Project	IEEE 802.16 Broadband Wireless Access Working Group < http://ieee802.org/16 >
Title	Proposed text to Subclause 1.3 Reference Models
Date Submitted	2007-03-09
Source(s)	Joey Chou Intel Corporation [mailto:joey.chou@intel.com]
Re:	
Abstract	This contribution proposes the text to subclause 1.3 Reference Models.
Purpose	Adoption
Notice	This document has been prepared to assist IEEE 802.16. It is offered as a basis for discussion and is not binding on the contributing individual(s) or organization(s). The material in this document is subject to change in form and content after further study. The contributor(s) reserve(s) the right to add, amend or withdraw material contained herein.
Release	The contributor grants a free, irrevocable license to the IEEE to incorporate material contained in this contribution, and any modifications thereof, in the creation of an IEEE Standards publication; to copyright in the IEEE's name any IEEE Standards publication even though it may include portions of this contribution; and at the IEEE's sole discretion to permit others to reproduce in whole or in part the resulting IEEE Standards publication. The contributor also acknowledges and accepts that

13 **Figure 1: WiMAX Network Reference Model**

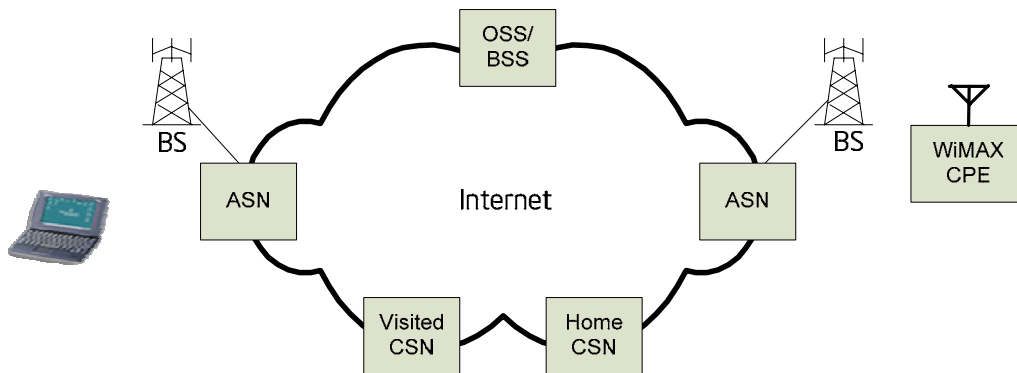
6 [\[Insert the following text to Subclause 1.3:\]](#)

8 Figure 1 shows the high level WiMAX network reference model. OSS/BSS (Operation Support System /
9 Business Support System) and WiMAX network elements are connected over the Internet that form the
10 "all IP" networks. The reference model supports both mobile and fixed broadband wireless access.

Figure 2: WiMAX OSS/BSS Reference Model

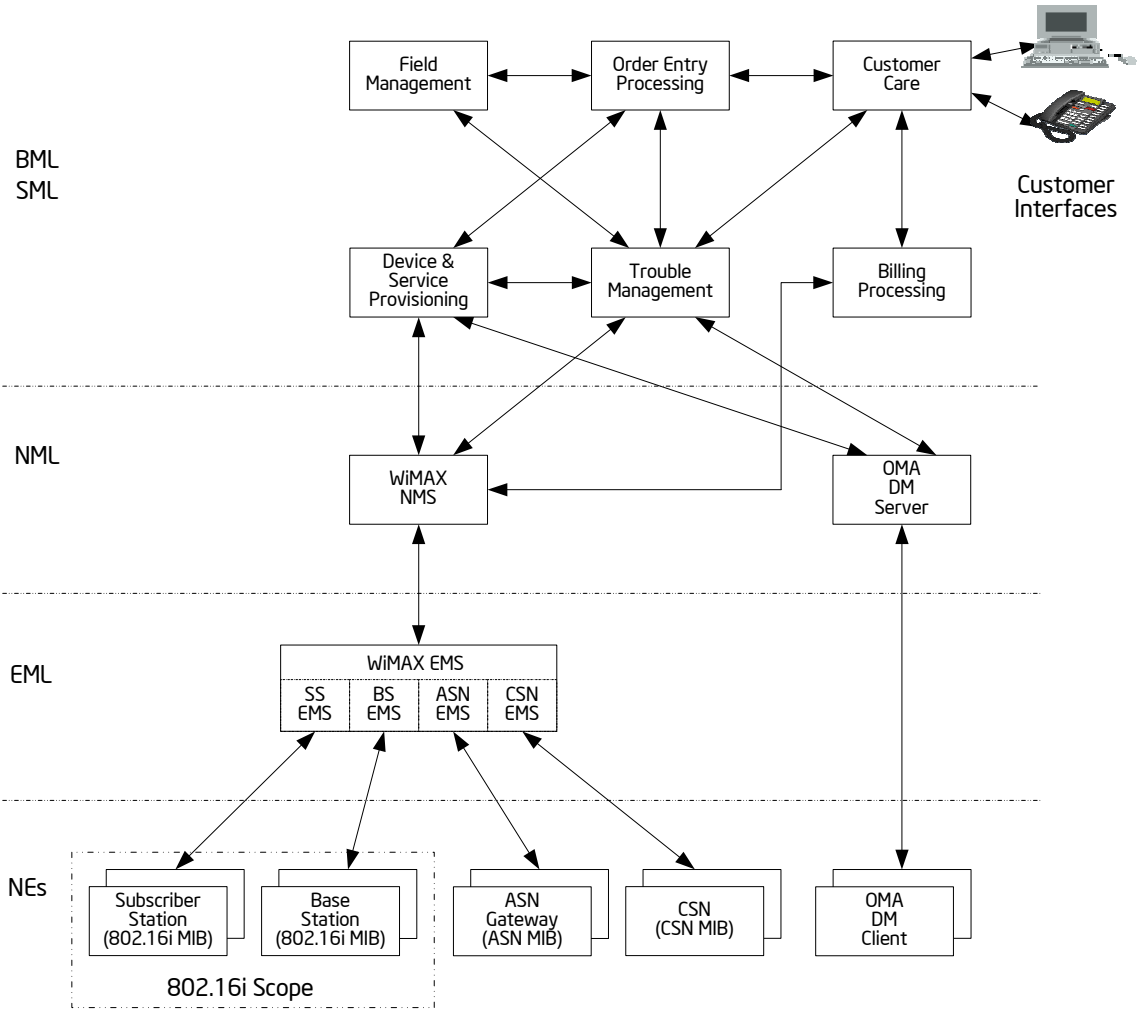
15 A TMN (Telecommunications Management Network) model has been proposed by the ITU and
16 TeleManagement Forum (TMF) to structure OSS/BSS management functions and define interfaces
17 between the functional entities. Figure 2 illustrates the WiMAX OSS/BSS reference model to describe
18 how IEEE 802.16i MIB is to interface with other management entities in order to support WiMAX
19 business development and operation.
